CBP LOT 2-1A

EL PASO COUNTY, STATE OF COLORADO
GRADING & EROSION CONTROL PLAN

GRADING & EROSION CONTROL PLAN
CBP LOT 2-1A
JOB NO. 44-034
DATE PREPARED: JANUARY 2, 2019
DATE REVISED:

EL PASO COUNTY FILE NO. PPR 19-000

GRADING AND EROSION CONTROL NOTES:

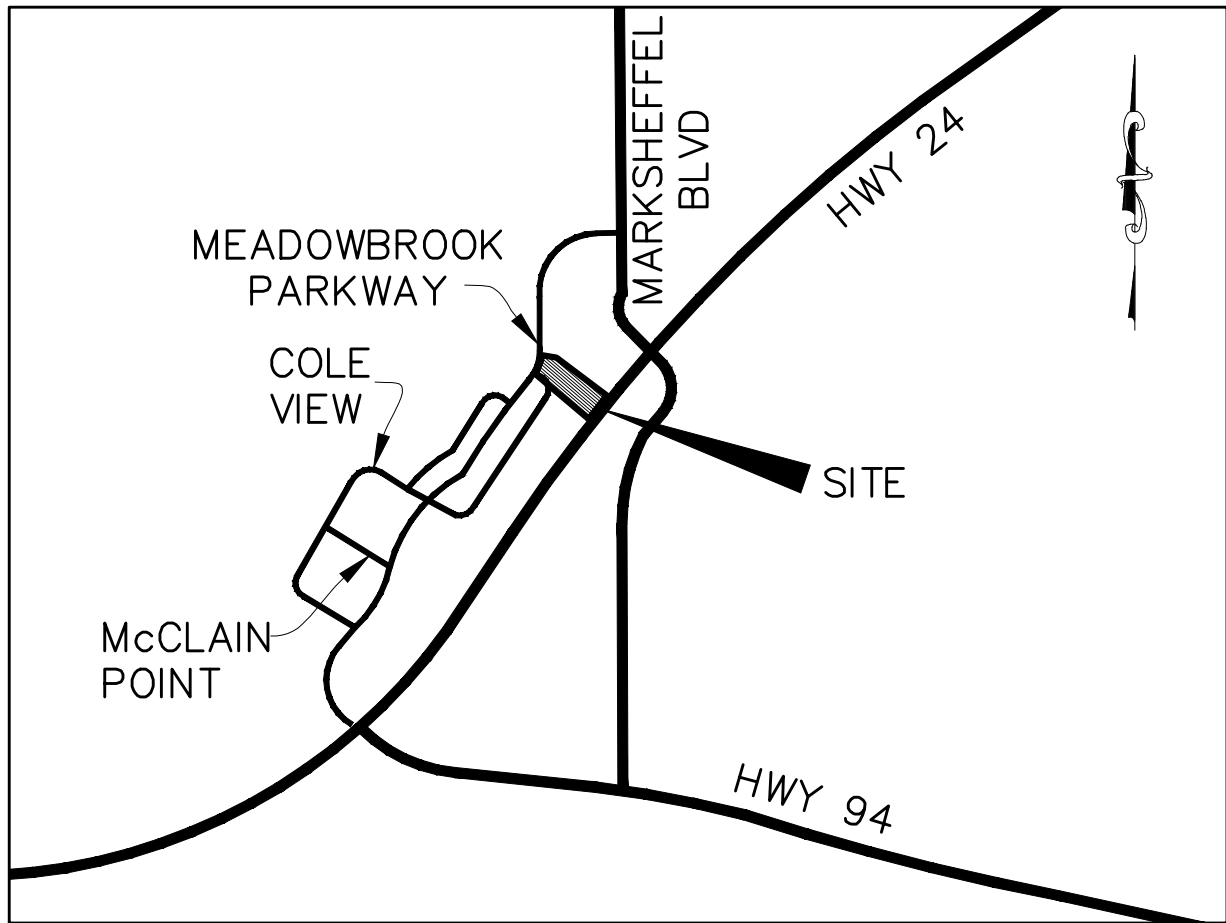
Revise "Development Services" to "Planning and Community Development"

Revise DSD to PCD
